PLANNING, ZONING, & BUILDING DEPARTMENT
PZ&B Staff Combination Memorandum: Architectural Commission and Town Council

SUBJECT: ZON-24-0023 (ARC-24-0029) 242 PARK AVE

MEETING: SEPTEMBER 25, 2024 ARCOM
OCTOBER 09, 2024 TC

Proposed west elevation.

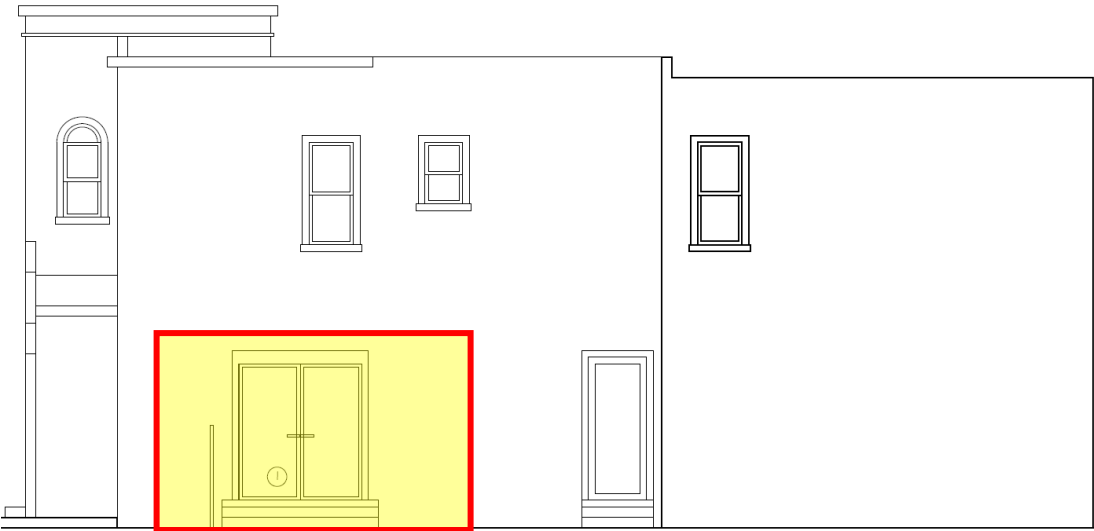
The applicant has resubmitted plans addressing comments of the commission from the August hearing. The arrangement of fenestration on the first floor street facing façade is proposed to remain. The applicant has resubmitted plans which now proposed modification to the west façade of the main massing to provide new glass doors which will open to the proposed new swimming pool. The changes are not readily visible from the Park Avenue right-of-way due to an opaque fence fronting Park Avenue with tall, dense plantings behind.

At the September 25, 2024, ARCOM meeting, the Commission approved (7-0) modifications to an existing residence. Additionally, the Commission approved (7-0) that the implementation of the proposed variances would not negatively affect the architecture.

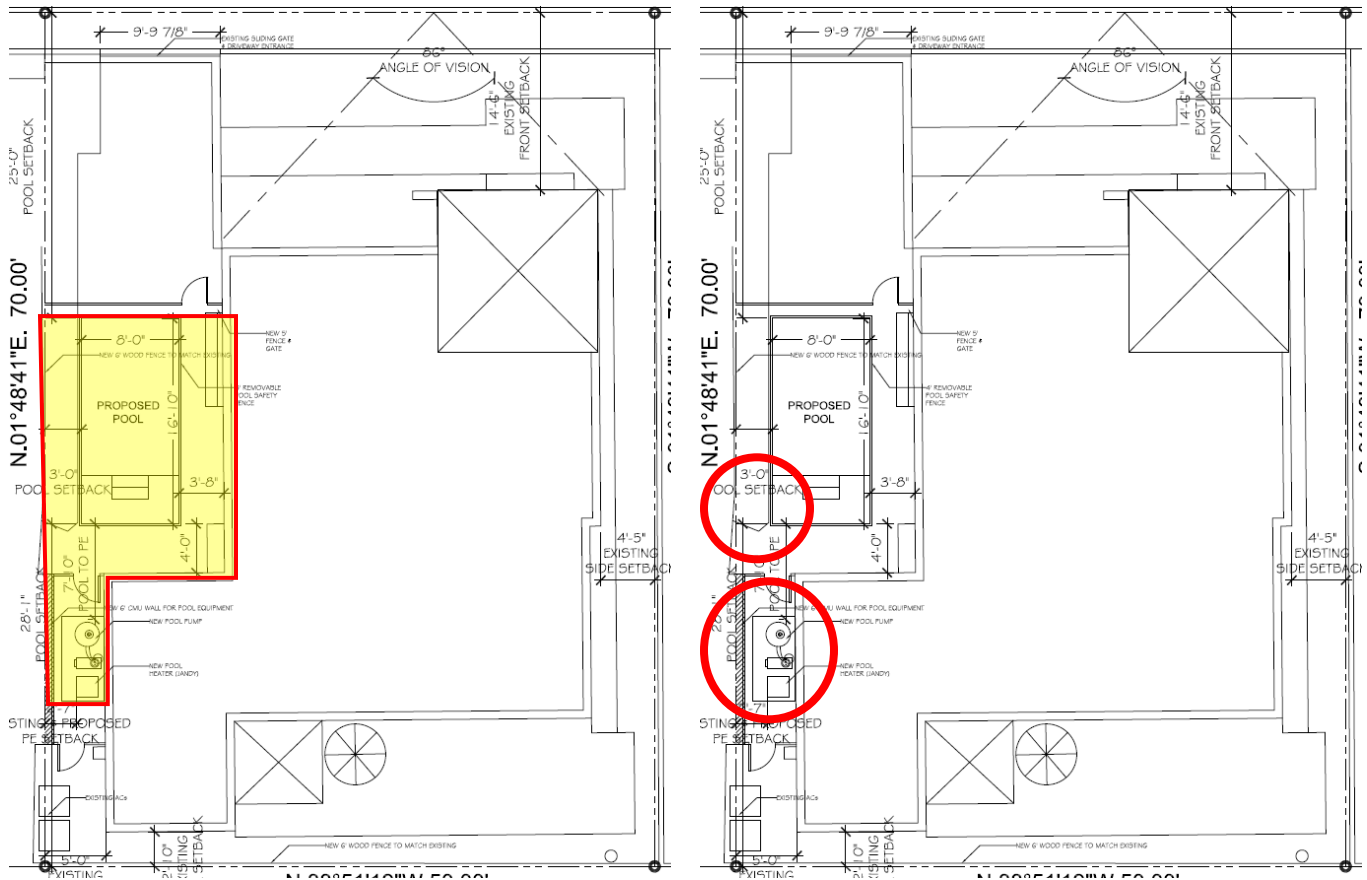
In addition to the fenestration alterations, the applicant also proposes the installation of a small plunge pool in front of the house. The placement of the pool is 25’-0” from the front property line and out of the required front yard setback. The swimming pool is proposed to replace the end segment of the existing driveway and a new 5’-0” high fence and gate will separate the pool area from the drive. The existing drive currently can park two (2) stacked vehicles. For a lot of this size, only one 9’ x 18’ parking space is required on site and the applicant proposes to maintain one parking space. The applicant affirms that the scope of work will not result in the loss of any existing open space, and that the swimming pool and any related hardscape improvements will occur within the current footprint of the existing driveway surface.

Code Section	Permitted/Required	Proposed	Variance
VARIANCE 1: Sec. 134-1757	10’-0” side-yard for swimming pools.	3’-0” swimming pool side yard setback	7’-0”

The subject property was constructed in 1939 with sited setbacks that are nonconforming in regards to today's zoning code—leaving very little room for the installation of a pool without seeking some form of zoning setback relief. All four directional yard requirements (front, both side, and rear) for the footprint of the building are spaced closer to the property lines than required. As previously mentioned, the existing site features many nonconforming aspects, and leaves few options for this type of improvement. As a result, 3 variance requests must be granted for the scope of work as it relates to pool setback and equipment setback. The variance previously requested to forgo masonry wall screening for the pool heater has been eliminated in this resubmission.
